Access Compliance Report

Public Rights-of-Way

(Curb Ramps)

Intersection ID: 3590	Main Street: SANDRINGHAM_PL	Cross Street: WEAVERS_GLENN_PL	Location:	N
ADA ID: A94205597FE2	Ramp Type: Perp	Initial Pass/Fail: Fail	Overall Compliance: No	Severity Score: 1.25
Codes/Mitigation Info/Possible Solution		Field Measurements/Component Compliance

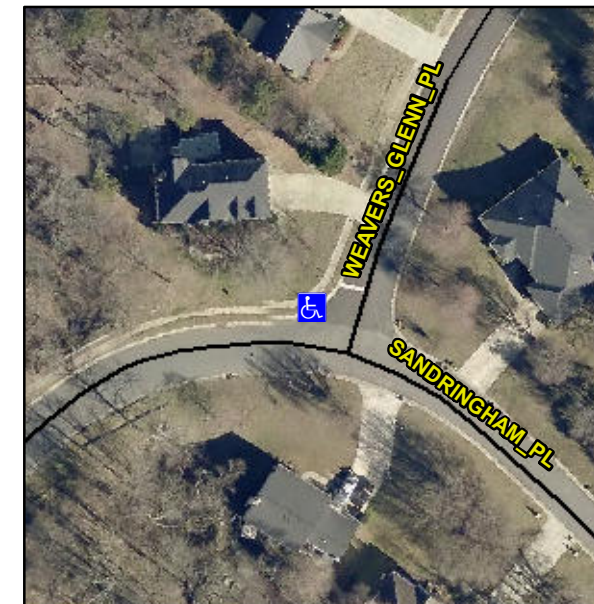
Not Found, R304.5.3

Compliance	Description	Data	Compliance	Description	Data
N/A	Ramp Length (in)	48.0	Yes	Ramp Slope (%)	5.0
Yes	Ramp Width (in)	52.0	No	Ramp XSlope (%)	3.5
N/A	Flare Type LT	N/A	N/A	Flare Type RT	N/A
N/A	Flare Slope LT (%)	N/A	N/A	Flare Slope RT (%)	N/A
N/A	Flare Traversable LT?	N/A	N/A	Flare Traversable RT?	N/A
N/A	Landing Length (in)	N/A	N/A	DWS Provided?	N/A
N/A	Landing Width (in)	N/A	N/A	DWS Contrast?	N/A
N/A	Landing Slope (%)	N/A	N/A	DWS Length (in)	N/A
N/A	Landing X Slope (%)	N/A	N/A	DWS Full Width?	N/A
N/A	Landing Curb? (Y/N)	N/A	N/A	DWS Offset (in)	N/A
N/A	Shared Landing?	N/A			
N/A	Gutter Ponding?	N/A	N/A	Gutter Slope (%)	N/A
N/A	Gutter Lip Ht (in)	N/A	N/A	Gutter X Slope (%)	N/A
N/A	Painted X Walk1?	No	N/A	Painted X Walk2?	N/A
	X Walk 1 Direction	To SW		X Walk 2 Direction	N/A
N/A	X Walk 1 Width (in)	N/A	N/A	X Walk 2 Width (in)	N/A
	X Walk 1 Slope (%)	1.1		X Walk 2 Slope (%)	N/A
	X Walk 1 X Slope (%)	2.7		X Walk 2 X Slope (%)	N/A

Remove & Replace Entire Ramp.
